7216 AURORA AVE N
DESIGN RECOMMENDATION
10 FEBRUARY 2022
SDCI Project: #3034281-LU

SITE 7216 Aurora Ave N

Administrative Design Review

MASSING

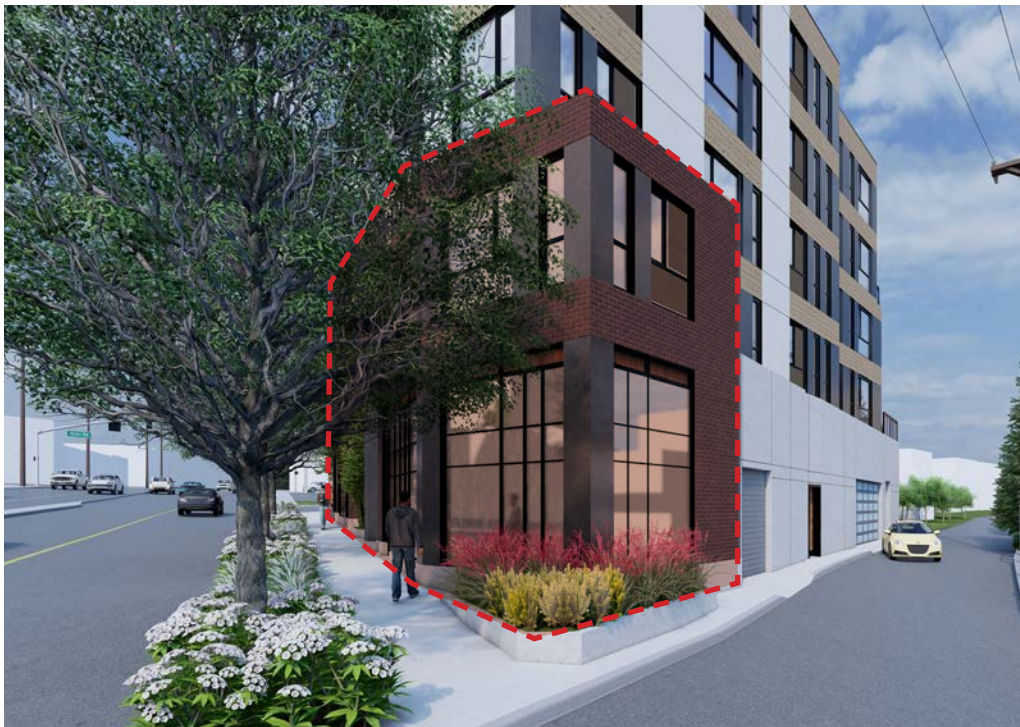
- 1. Staff supports the applicant’s massing option that presents a two-story base along the street edge and varied upper levels that offer scale and legibility. (CS3-A-1, DC2-A-2)

- 1. Two-story base has been developed to simplify the storefront system further into a more linear and cohesive street edge. The initial design was developed as a series of individualized storefront panels, the redesigned pedestrian edge connects these storefront sections into a cohesive linear element which abuts the sidewalk. This creates a much clearer residential and commercial edge for the building.

GROUND LEVEL USES & ENTRIES

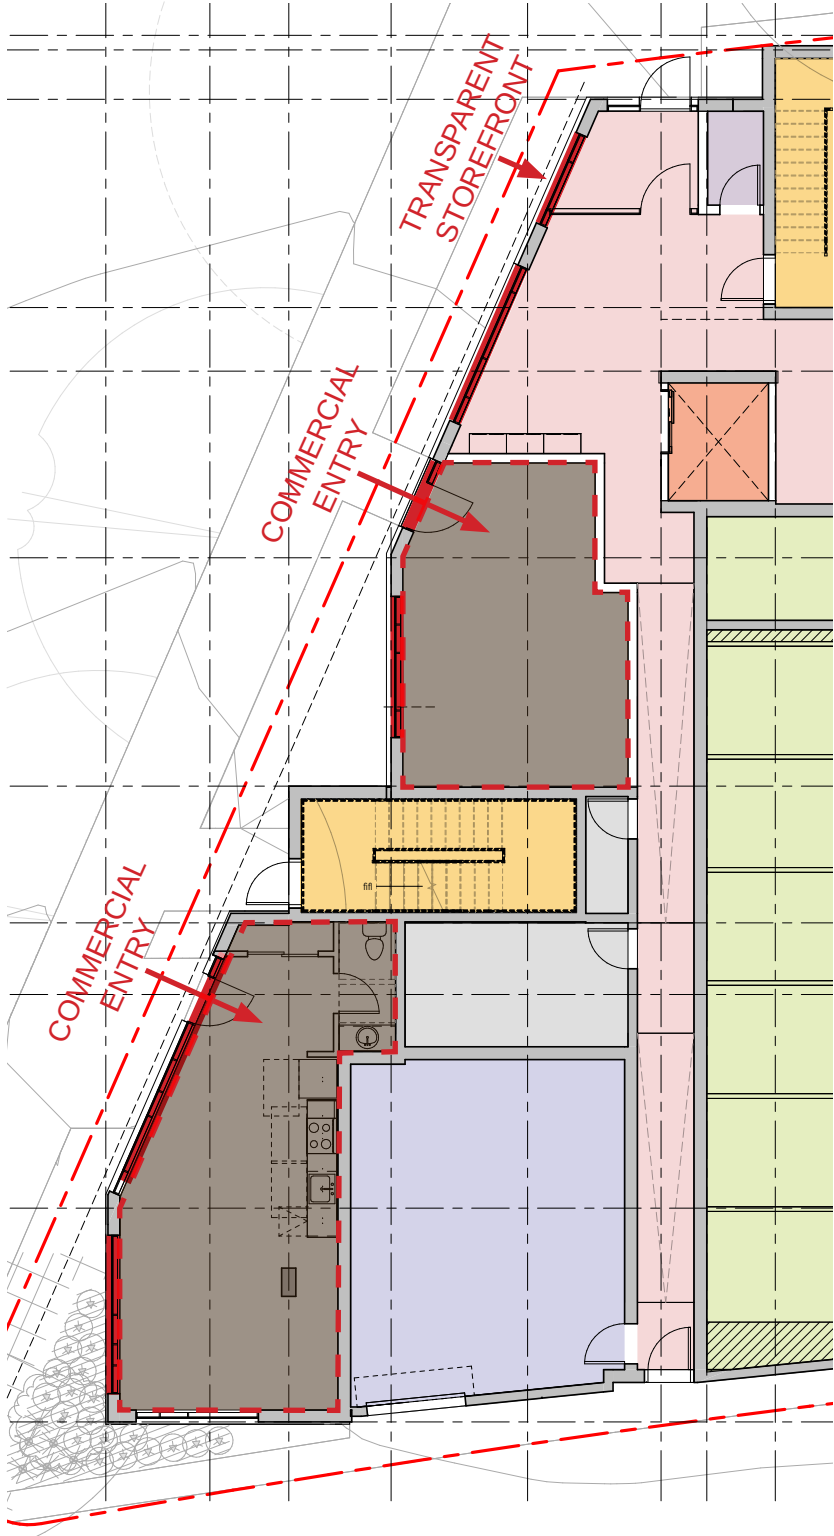
- 1. The ground level uses continue to be problematic in that several ‘back of house’ uses are located along the street...
 - i. One of the two live/work units has direct access to the street while the other causes the visitor to walk through three doors before reaching the second live/work space...
 - ii. The Design Guidelines speak to porous retail edges...
- 2. Staff appreciates the applicant relocating the residential lobby entry...
- 3. It is challenging to distinguish between the live/work entry...

- 1. The first floor has been redesigned in order to express the more public side of the building. Bicycle parking has been relocated to the parking garage and both commercial spaces have been elongated in order to lengthen and create a storefront which is more cohesive and has a larger area of coverage. The stairwells serve as a verticle element that breaks up the rythm of the upper sections of the building as well as connecting the upper roof down to the ground level.

- i. Commercial spaces are designed to exclusively enter through direct street access off Aurora.
 - ii. The first floor revision has increased the storefront transparency coverage at the retail edge by increasing the coverage by the commercial areas. The facade along Aurora is now 66% transparent and the setbacks along the Aurora facade are now occupied by landscaping planters to decrease the emphasis on these secondary elements.

- 2. The residential entry remains oriented towards Keen. This entry has been further emphasized by a linear canopy which covers both the commercial space and turns the corner to Keen way.

- 3. Live/work units are removed and replaced with commercial spaces. The entry to these spaces has been reoriented to Aurora.

FACADE COMPOSITION

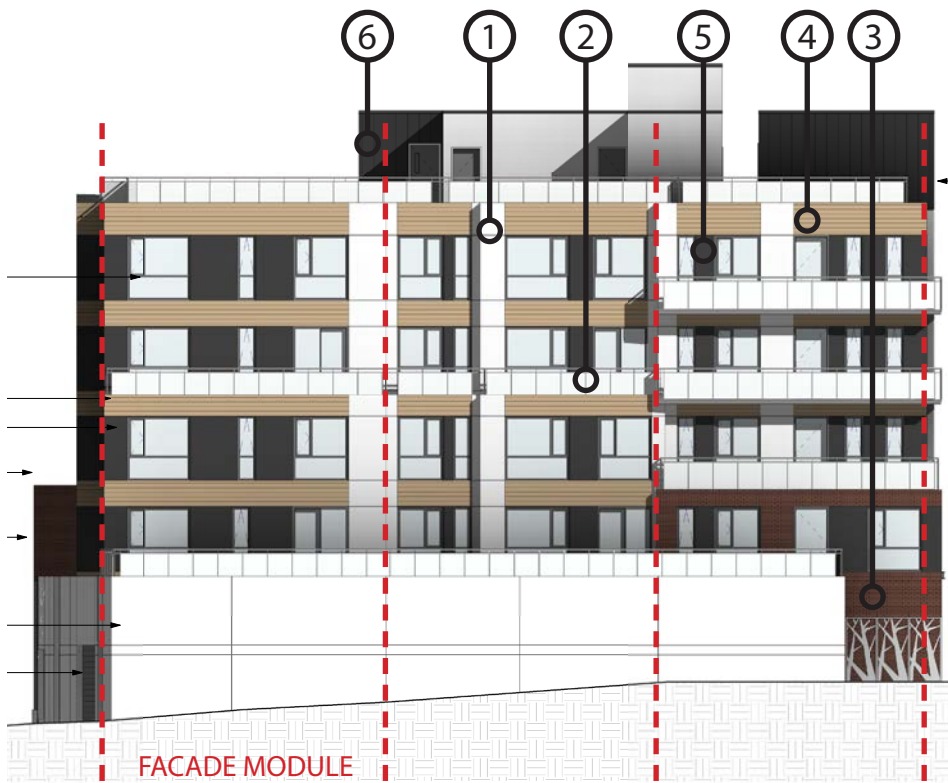
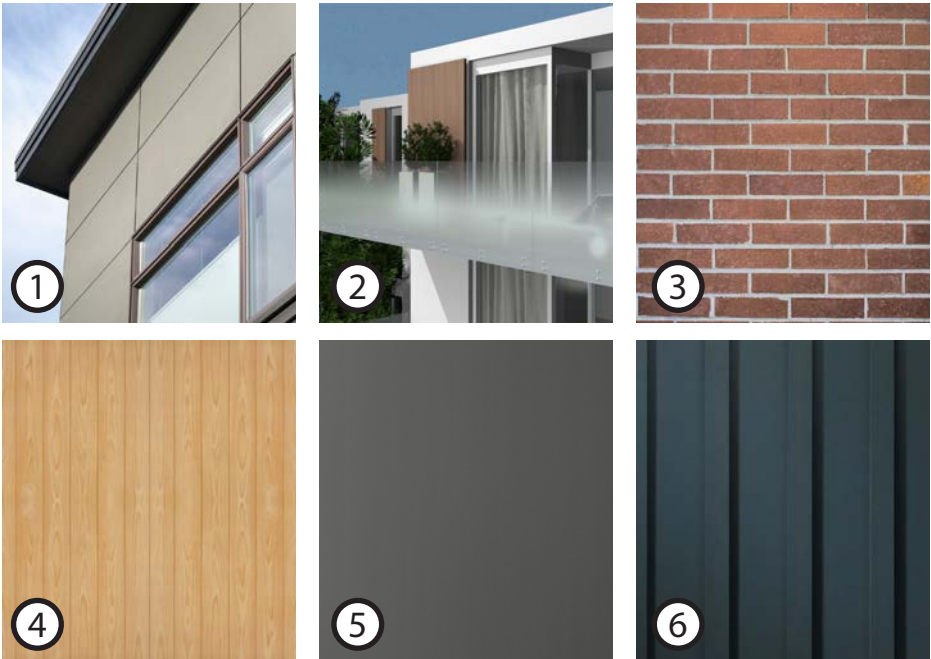
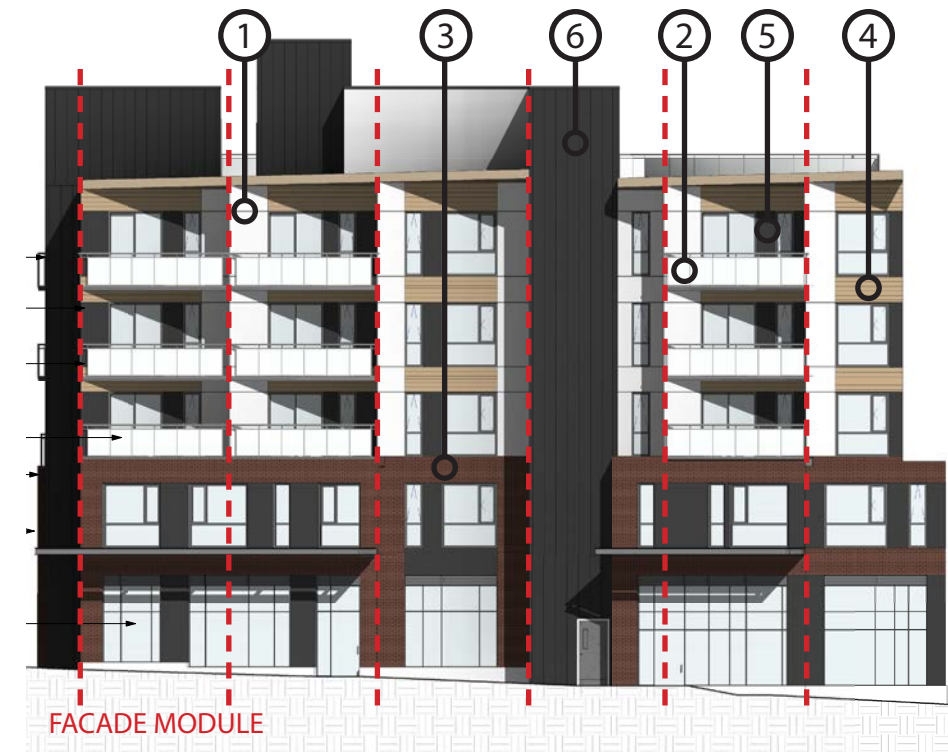
- 1. Although staff appreciates the applicant’s efforts to provide scale and visual interest on the upper levels, staff acknowledges there appears to be little cohesion and hierarchy of elements and the application of materials should be simplified to strengthen the design concept. (DC2-B-1)
 - i. The precedent image on page 22 of the design review packet is successful in that the roofline is flush with carved voids clad in wood and the addition of balconies help accentuate the voids. Small revisions to the west façade to the concept and composition to help clarify the form will be successful in creating a simple, cohesive project. (DC2-B-1)

- 1. The facade materials and composition has been redesigned and recomposed to create more evenly spaced bays and reduce the number of materials and secondary elements at each facade. Each facade has been recomposed to create a more cohesive design through the entire project. The project now has two clear languages; the brick and storefront base which extends to the second floor and the upper floors which is composed of white FCP, wood-look accent panneling, and dark metal panel between windows.

- i. Roofline has been redesigned to be aligned across the entire facade along Aurora and the roofline has been reduced back to create a more clear connection between the line of the roof and the carved voids along the facade. Balconies hav also been added to the facade in order to express a more clear horizontal composition of the facade. The simplification of all facades as detailed above has also created a more clear and cohesive design.

SINGLE FAMILY ZONE TRANSITION

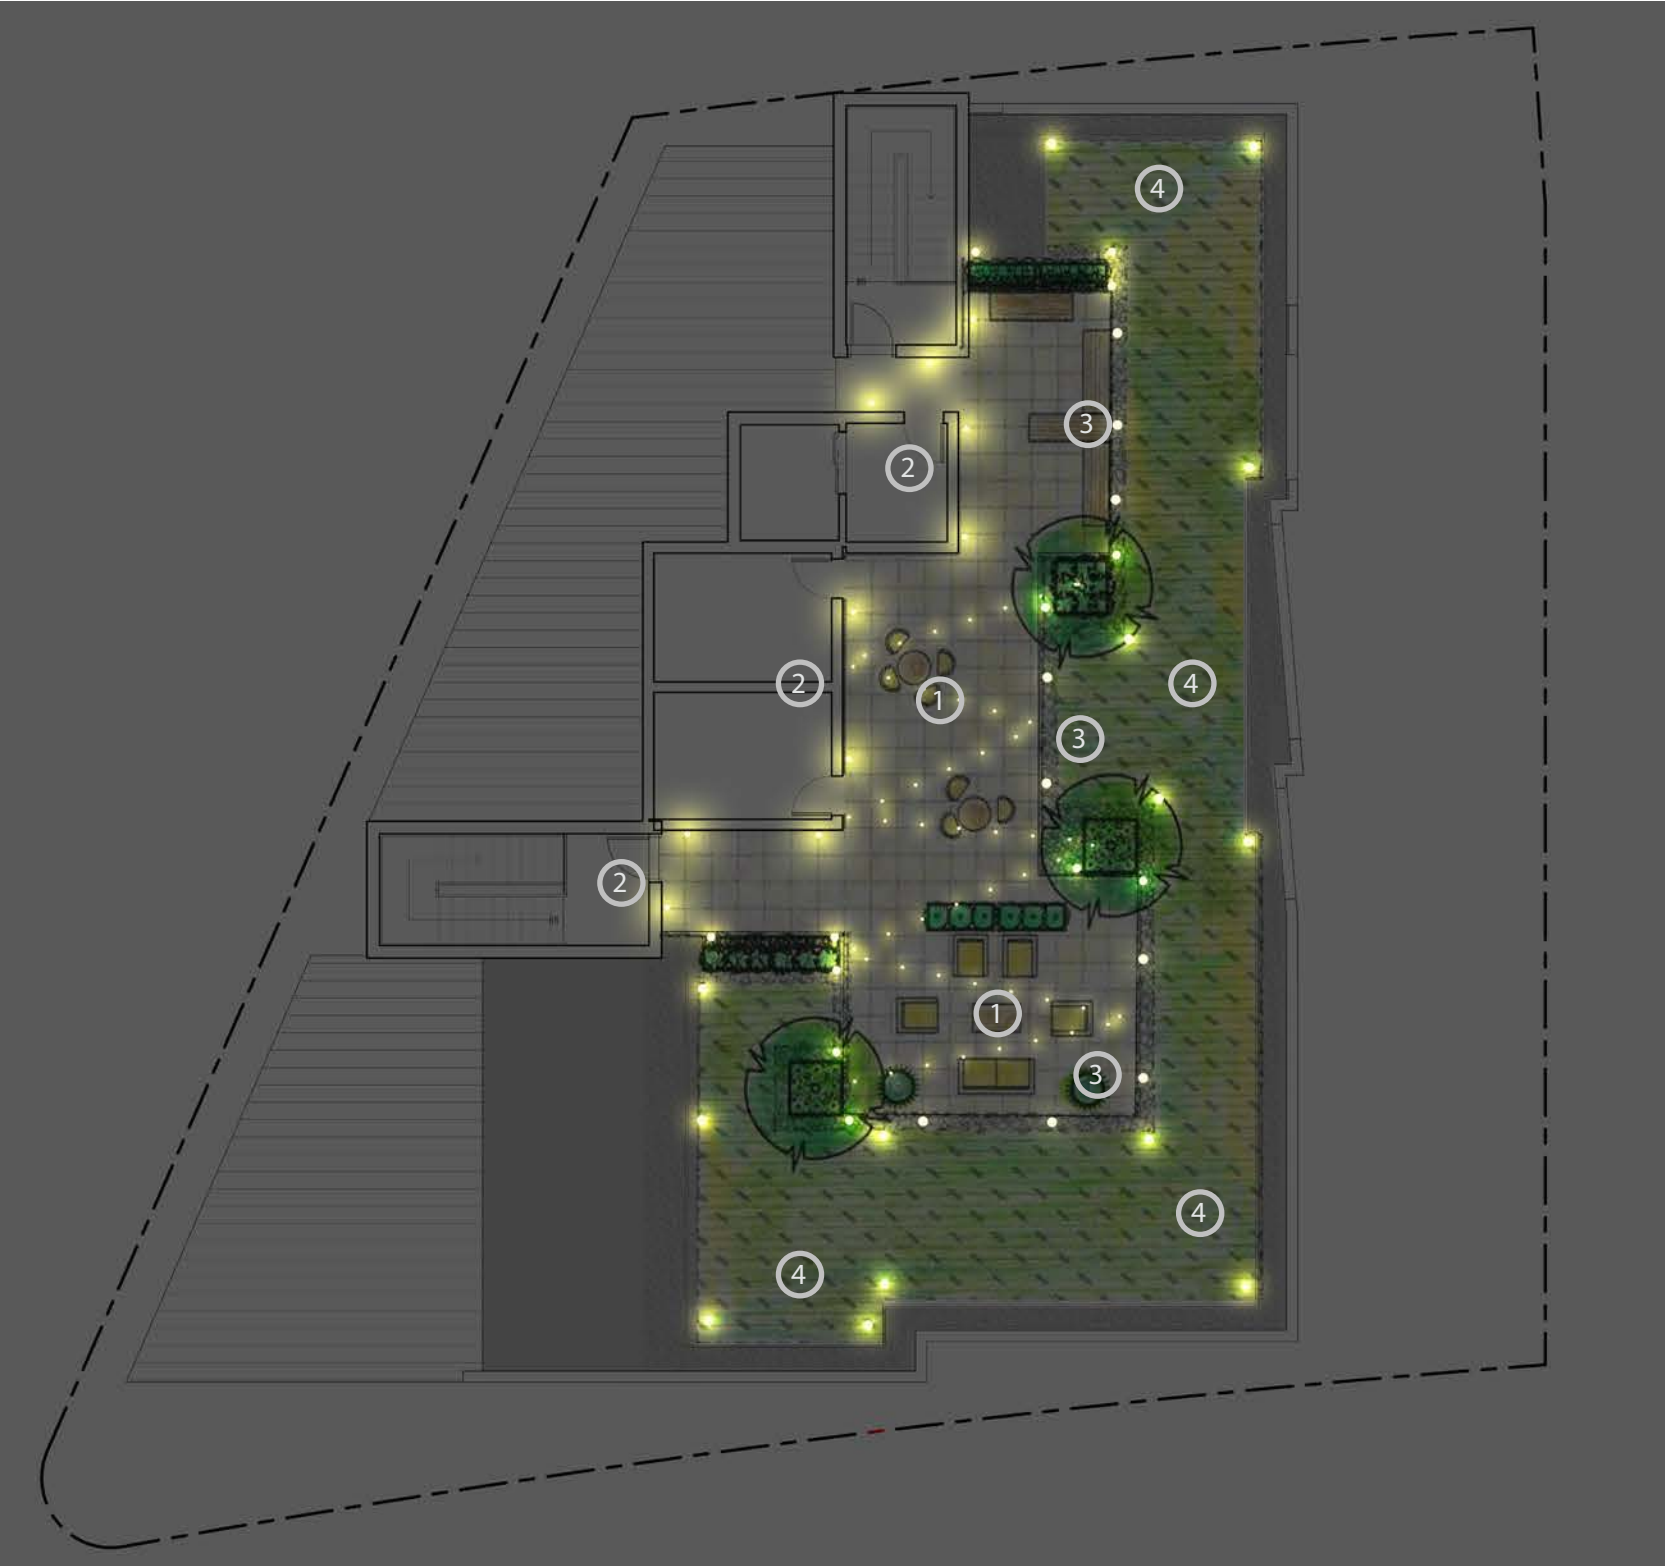
- 1. The blank wall condition along the north façade, fronting Keen Way North, is problematic. Staff recommends replacing the wall with decorative metal screening to shield the parking while also providing visual interest and an opportunity for artwork as a transition to the single-family zone. (DC1-C-2, DC2-B-2)
- 3. Staff questions the need for stairs to the private amenity space from Keen Way North. (PL2-D-1)

1. Staff supports the applicant's massing option that presents a two-story base along the street edge and varied upper levels that offer scale and legibility. (CS3-A-1, DC2-A-2)

- 1. Decorative metal panelling has been added to this facade to deemphasize this blank wall contition. Additional landscaping and planters have also been added to this location to further deemphasize the condition.
- 3. This secondary access stair to the private amenity space along Keen has been removed.

-
2. This wall currently abuts a high fence on this property as well as vegetation which significantly decreases it's presence. The wall itself will be composed of high quality concrete with reveals.
